## **Appendix N: Correspondence**

### **RE: North Dam – Quality Assurance Program**

## **Notes on Conference Call: March 4, 2011**

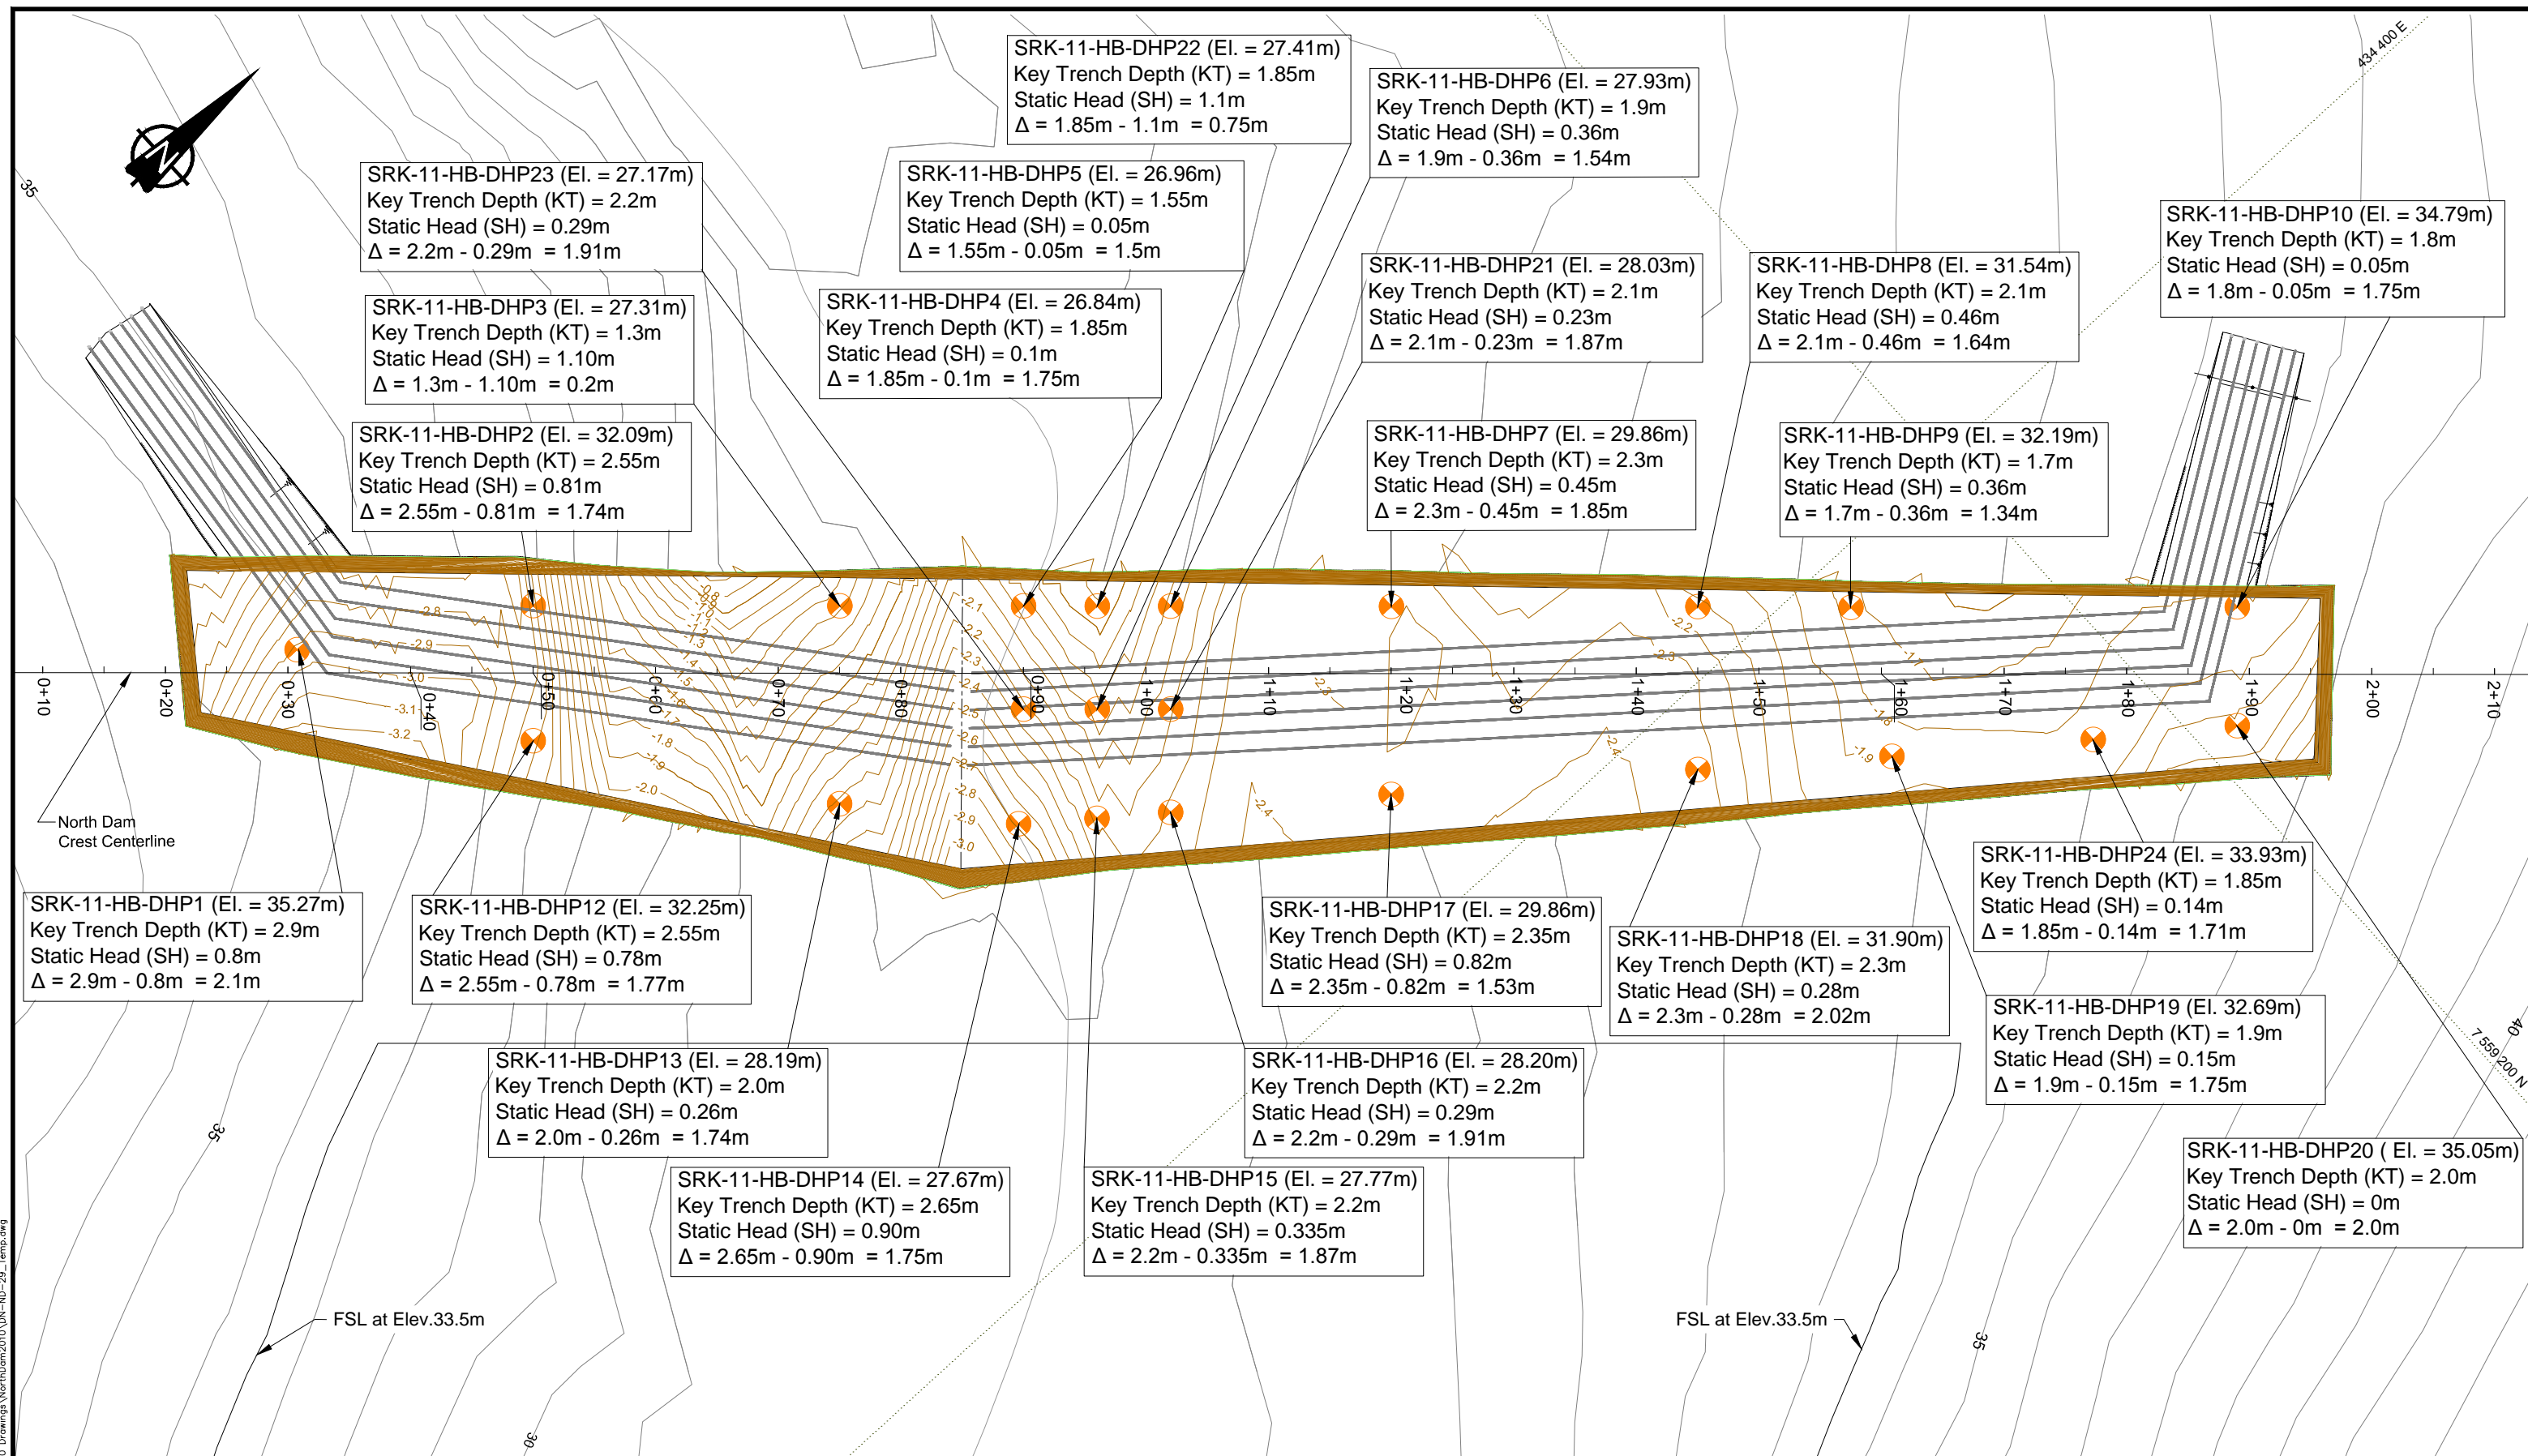
The percolation tests along the key trench footprint of the North Dam have been completed and the test data have been analyzed and reviewed. The test results are presented in the attached spreadsheet as well as the PDF drawing for your information.

Taking these elements into consideration, and after taking into account the percolation test results, as well as the drill logs completed to date we conclude that NO CHANGE is justified to the current key trench design grades. We have discussed this with our colleagues at EBA and they are in agreement with our conclusion.

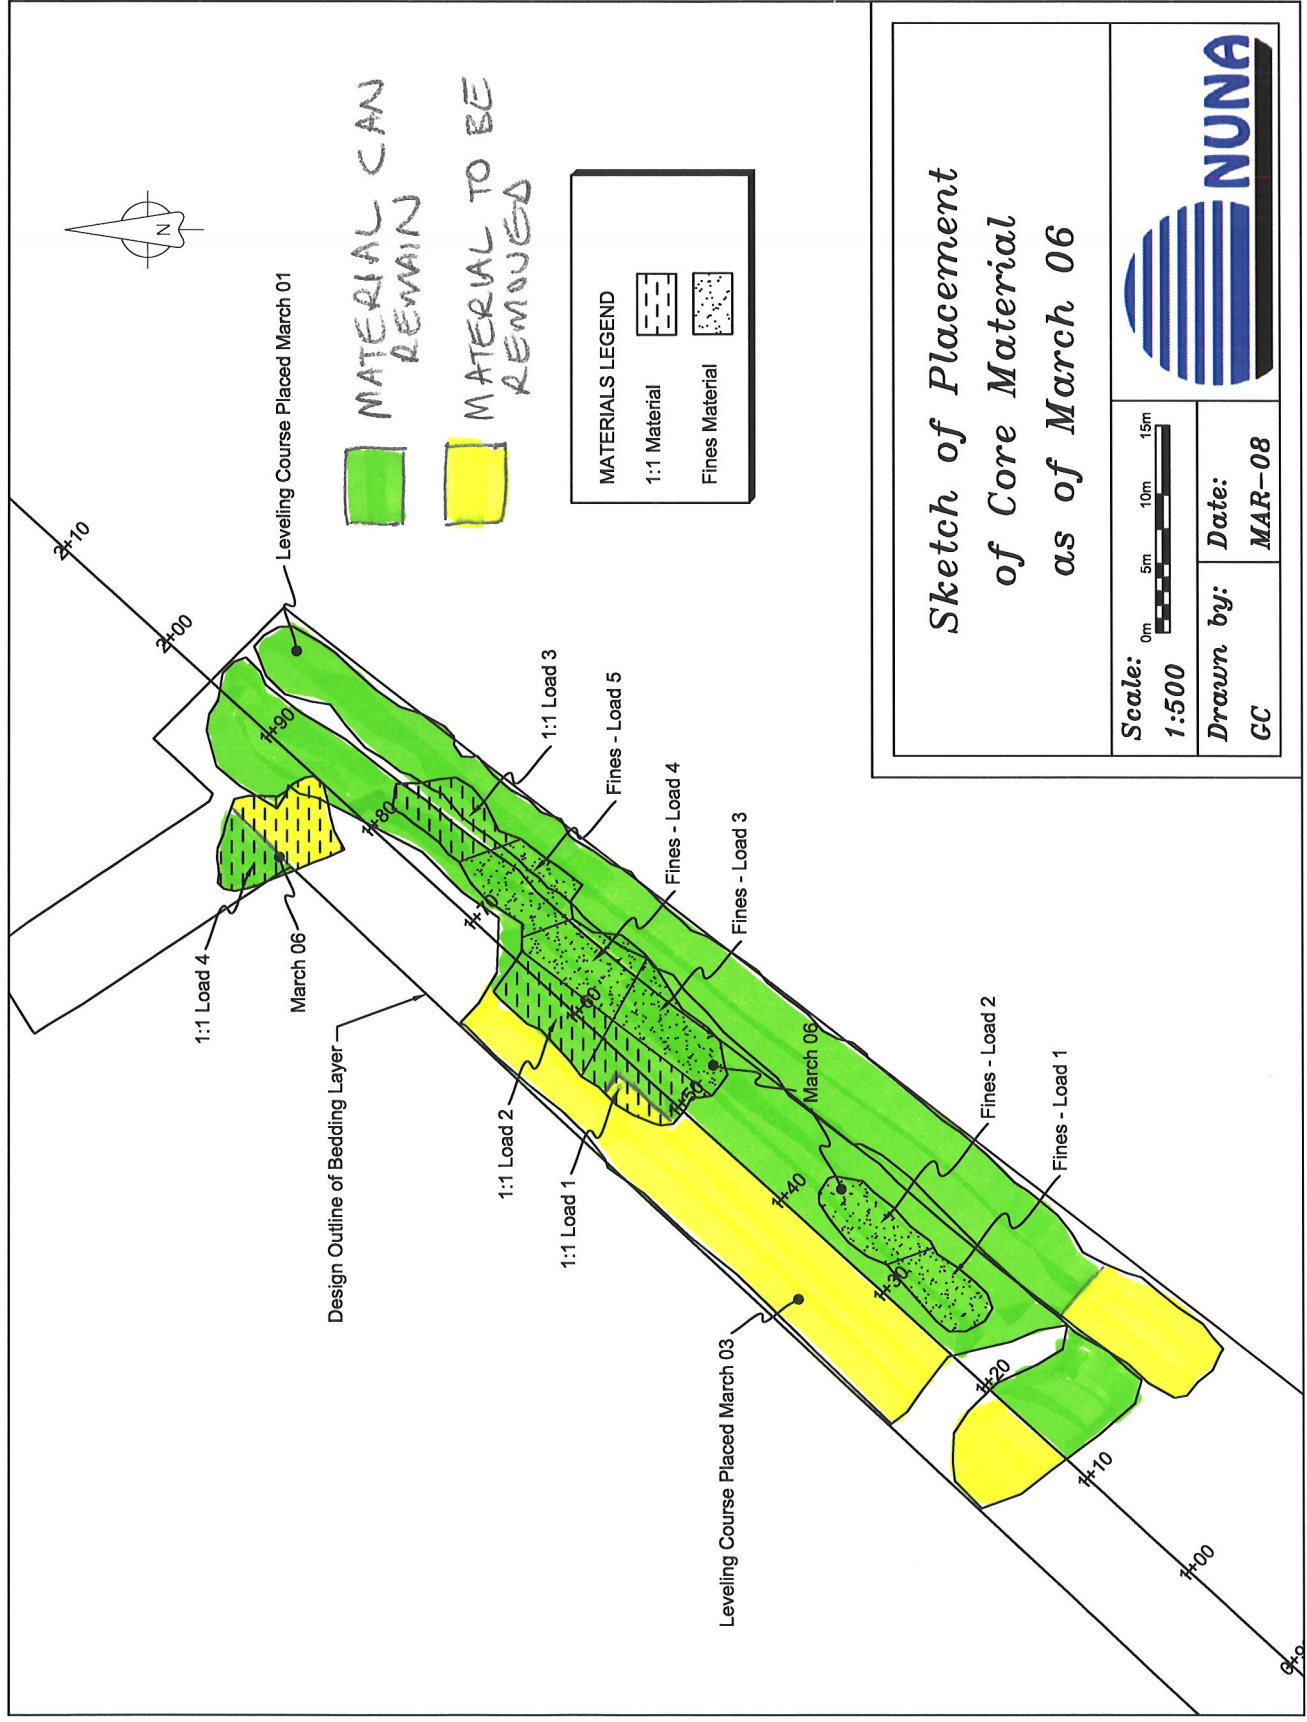
Review of the core material placed on March 1, confirms that the material placed north of station 1+20 meets specification, although right on the lower end) and can be left in place. Material to the south of this station must however be removed as it's degree of saturation is too low (see attached data sheet). Review of the core material placed on March 3, confirms that significant portions of the placed material does not meet the specified saturation or compaction limits (see attached data sheet). This material should therefore be removed in its entirety. The test pads placed on March 6 was however placed over portions of this compromised material and on closer review and in the essence of moving ahead expeditiously without compromising the integrity of the dam, SRK would be satisfied to leave a portion of this placed material in place provided a strip (at least 3 to 4 m wide) on the downstream side of the key trench is removed and replaced with core material that meets all specifications. The area in question is marked on the attached drawing. In addition, to ensure we have no possible short-circuiting of seepage, we will require the GCL to be extended to the back of the key trench in this area. At first glance we expect the additional GCL would be about 100 m<sup>2</sup>, although this would have to be confirmed.

Wrt the test pads constructed on March 6, all loads conducted with the "fines" met specifications and can be left in place. The first and final loads of the 1:1 mix of "fines" with core material did not meet specification. SRK will visually examine these areas and make a determination on whether it should be removed or may remain in place (these areas are also marked on the attached drawing)

DATE: March, 2011  
APPROVED: EMR/LW/JK  
FIGURE: 1

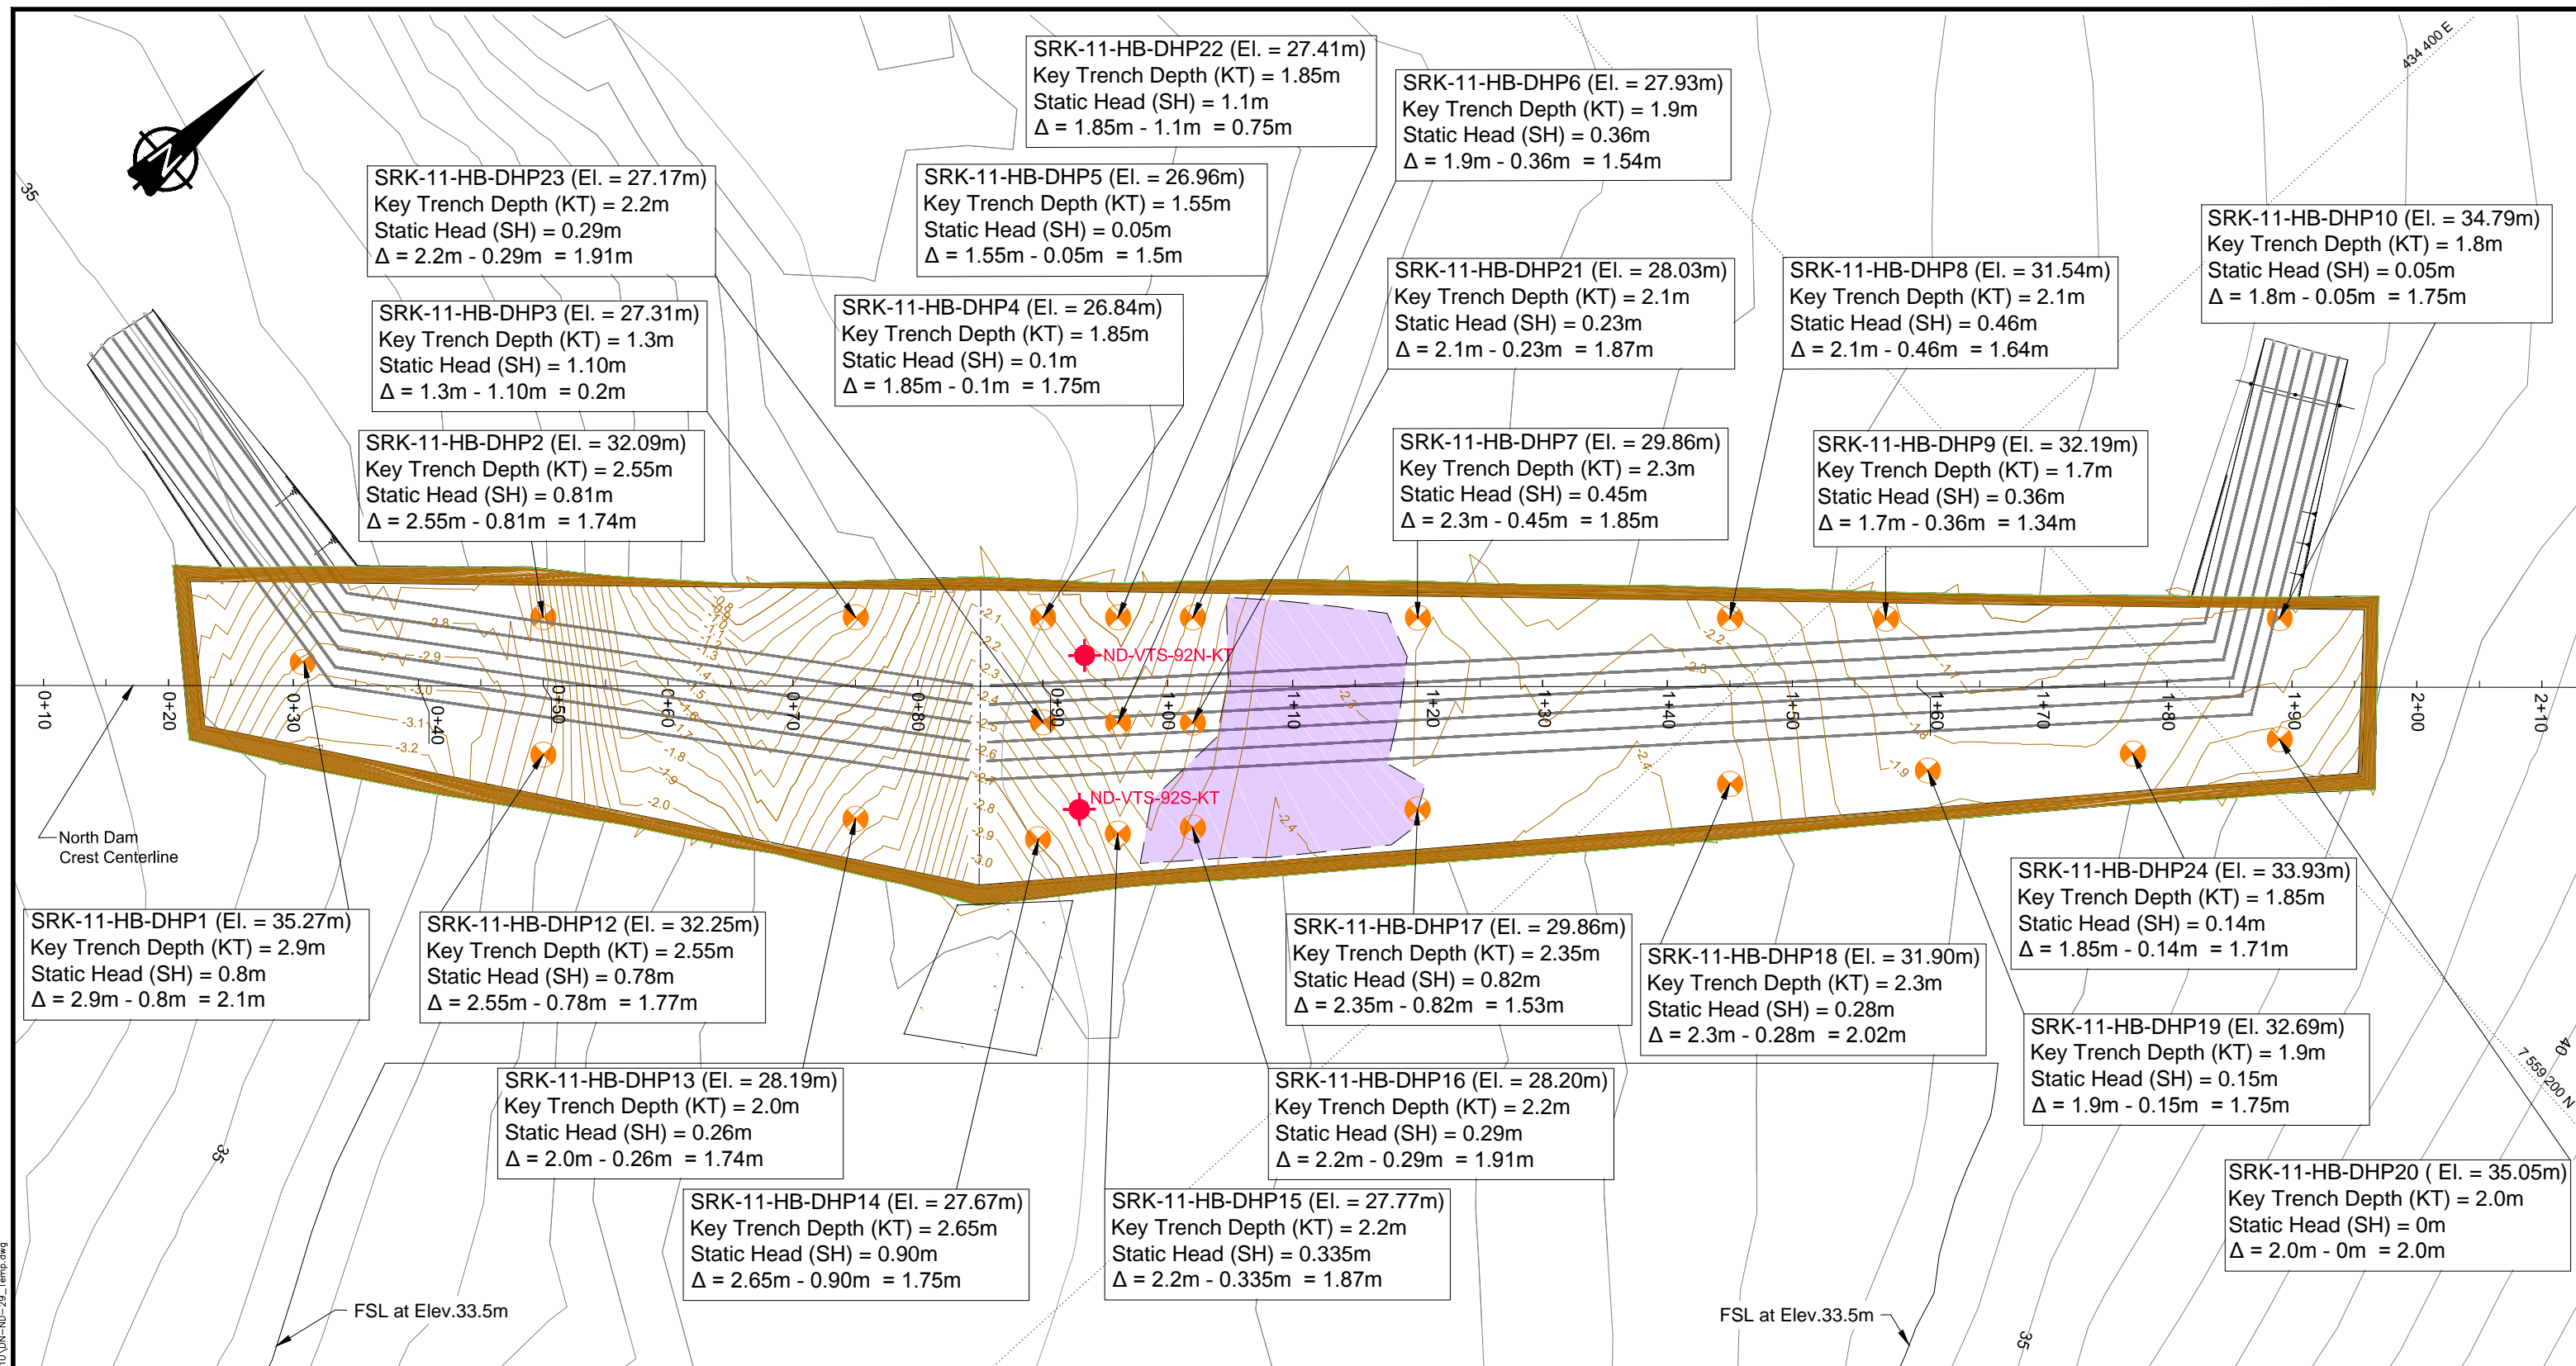
- e. Based on visual observation the possible extent of the area was demarcated with the aid of the surveyor (see attached drawing)
  - f. Two samples was collected from the area where the hole was dug for salinity and index property testing

## Fillet Zone Variance

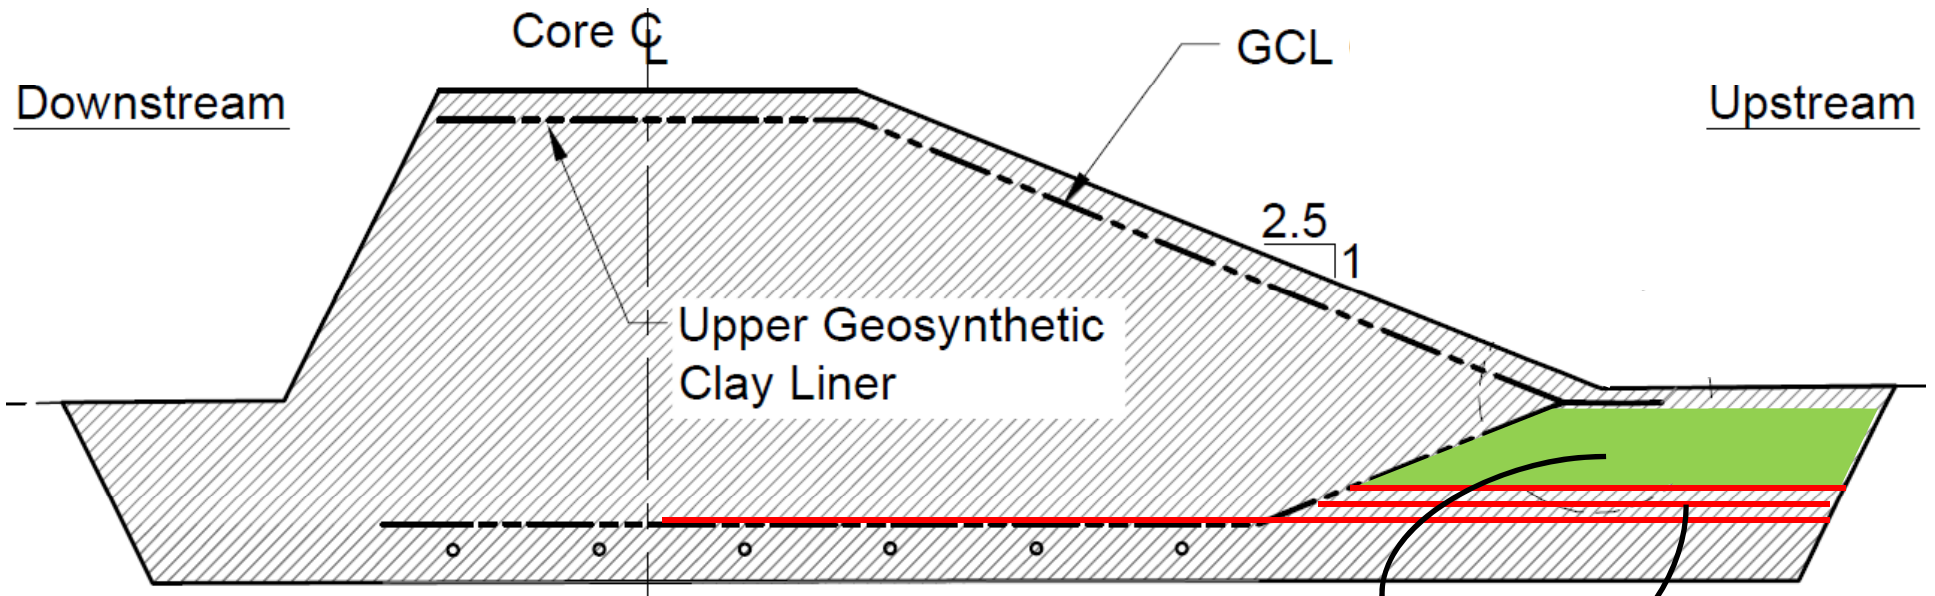
- Use blended core material as per rest of core, i.e. no variance on material type
- Ensure 95% Standard Proctor Density
- Moisture content no less than optimum Moisture Content (OMC), but no requirement to meet the 85% saturation
- No freeze back wait period between lifts
